Our Ref: 19502

5 November 2020

**RE: COSTCO LAKE MACQUARIE
ADDENDUM TRAFFIC REPORT**

The Transport Planning Partnership (TPPP) has prepared this addendum traffic report to review the traffic and parking related comments received from Lake Macquarie City Council (Council) and to provide response to address these comments.

Figure 1: Fotheringham Street Access

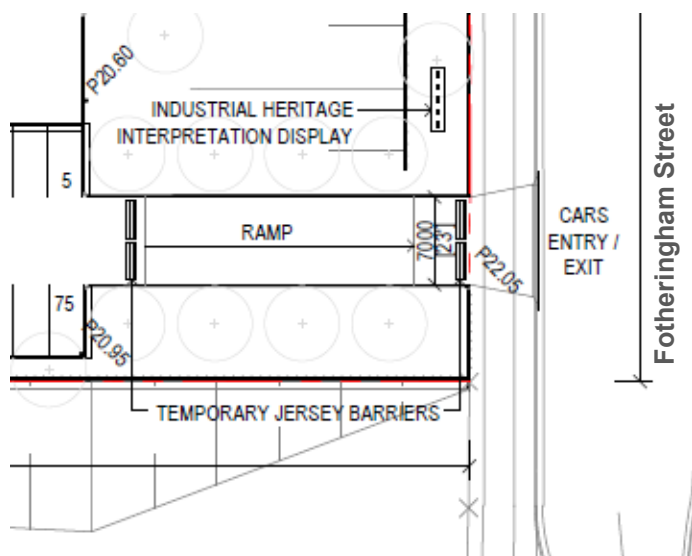
I have considerable concern regarding the use of Fotheringham Street and Main Road as key routes to the development. Fotheringham Street, including the Fotheringham Street/Main Road roundabout, has been designed as a residential street servicing a residential subdivision, including residential properties fronting. However the impact of connecting Fotheringham Street to both the development and Munibung Road is likely to result in it becoming sub-arterial in nature, utilised to relieve the arterial road network. This will create a significant future burden on both the residents of Fotheringham Street, and on Council to resolve the competing purposes of the road.

- *Adjust the Pasminco Area Plan to remove the connection of Fotheringham Street with Munibung Road for motor vehicles, allowing a cycling and walking connection for permeability purposes (without modelling to demonstrate otherwise, this is the favoured position of the Infrastructure Assets Strategy team (including traffic and transport officers)). Access to the development would then be as reflected in the TIS without impact from short cut traffic, and could be considered suitable subject to analysis of the impact on Main Road and suitable measures being provided to mitigate this impact.*
- *Do not provide a vehicle access from Fotheringham Street into the development and adjust the traffic model in the TIS to suit. This option would allow the development to proceed without the need to resolve the future use of*

Costco would like to continue to seek approval to construct a secondary access onto Fotheringham Street as shown in Figure 1 as this ultimately reduces the pressure on the Hague Road and Reserve Road accesses in the long term.

However, Costco are aware that use of that access will not be allowed until upgrade works to Fotheringham Street are completed. Accordingly, Figure 1 illustrates that temporary jersey barriers will be installed at the top and bottom of the ramp to prevent use of the access in the short to medium term.

Temporary jersey barriers will be installed at the top and bottom of the ramp to prevent use of the access in the short to medium term

Figure 6: Munibung Road-Bunnings Access-Costco Access Intersection Layout

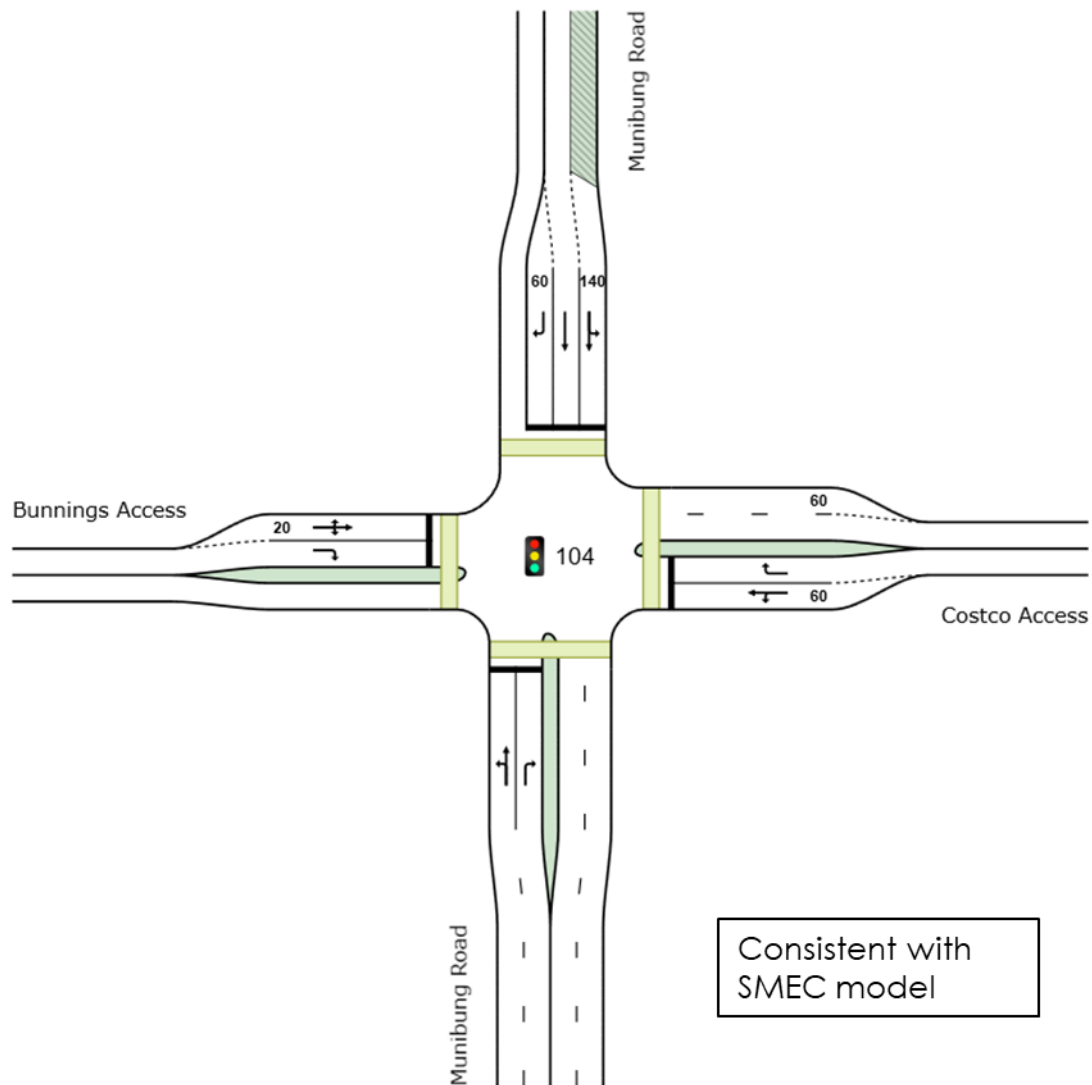
- Signal phasing at Munibung Road – Bunnings Access – Costco Access intersection has been updated to accommodate a standard single diamond phasing as per TfNSW's advice.

These changes have been adopted in TPP's model in response to TfNSW's required modifications in accordance with TfNSW Guides for Developing Standard for Single Diamond Overlap Phase (2009).

Figure 7: Munibung Road-Bunnings Access-Costco Access Phasing Diagram

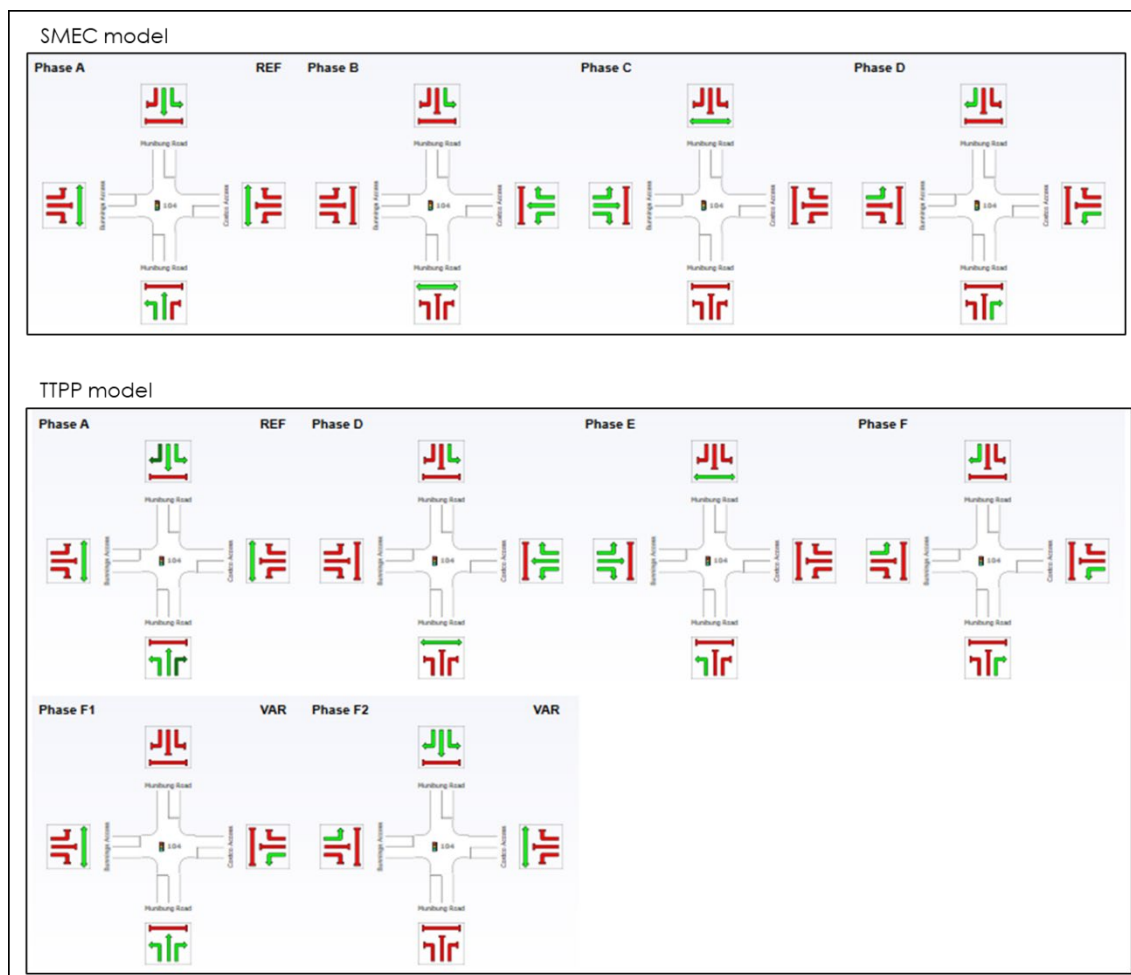
Figure 7 shows the traffic signal phasing adopted in the SMEC model. TfNSW required modification to the phasing adopted in the SMEC model for a standard diamond phase including Phase A, D, E, F, F1 and F2. It is required to provide a filtered right turn option in Phase A and a left turn movement into Bunnings Access Road in Phase C (now called Phase E).
